UNITED STATES PATENT AND TRADEMARK OFFICE

APPLICATION NO.	FILING DATE	FIRST NAMED INVENTOR	ATTORNEY DOCKET NO.	CONFIRMATION NO.
10/019,689	01/04/2002	Gerd Eisenblatter	87307.00025	7795

Office Action Summary

DETAILED ACTION

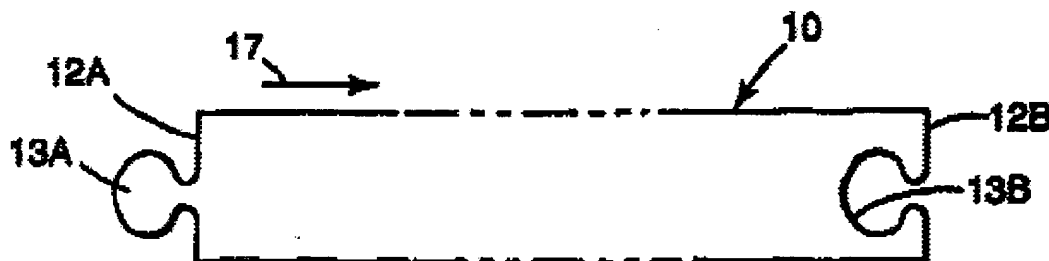
In view of specification and 112 rejections above, if the Applicant's attempt is to claim a key-hole shape as in Figs. 1 (a-c), obviousness rejection of the above claims over Muller applies as follows:

Muller discloses all the limitations of claim 1, except for disclosing a hole with a wider region on top and a narrow region on the bottom, since applicant has not disclosed that these specific shapes, e.g., key-hole, solves any stated problem or is for any particular purpose and it appears that the invention would perform equally well with hole as disclosed by Muller, it would have been an obvious matter of design to use a key-hole shape, however, It would have been obvious to one of ordinary skill in the art, at the time the invention was made, to modify the hole (18) by providing a keyhole shape for easier mating operation with the counterpiece (19).

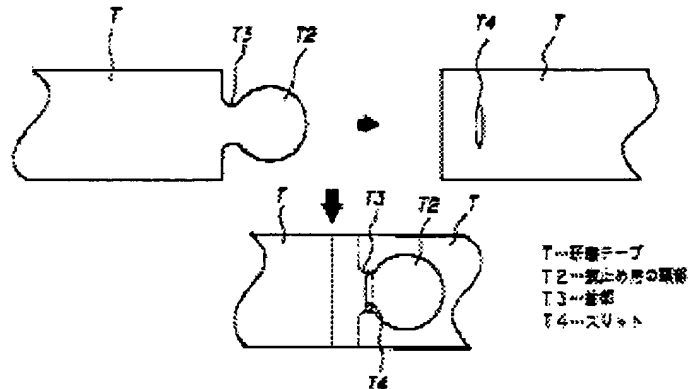
Stubbs et al. discloses all the limitations of claim 1, i.e., an interlocking abrasive belt having a keyhole shape (13B) and a counterpiece-

locking mate (13A), except for disclosing a closed end for the hole.

Takagi et al. teach an interlocking abrasive member with a recess having a closed end. It would have been obvious to one of ordinary skill in the art, at the time the invention was made, to modify the interlocking members of Stubbs et al. with a closed end as taught by Takagi et al. to strengthen the recess.

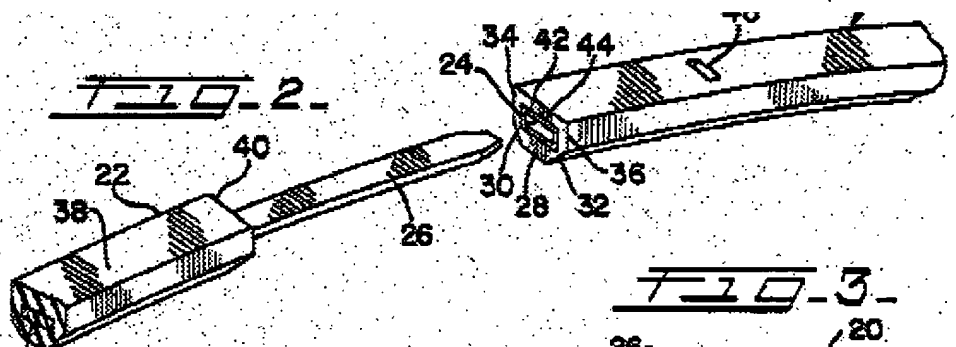
Prior art as applied to claim 1 above meets all the limitations of the above claims except for disclosing a coated stiffened end region. Razien teaches a drive belt having interlocking members (24) (26) wherein one of the members is stiffened and coated with Teflon™. It would have been obvious to one of ordinary skill in the art, at the time the invention was made, to further modify the modified invention of the prior art with hardening coating agent as taught by Razien for durability.
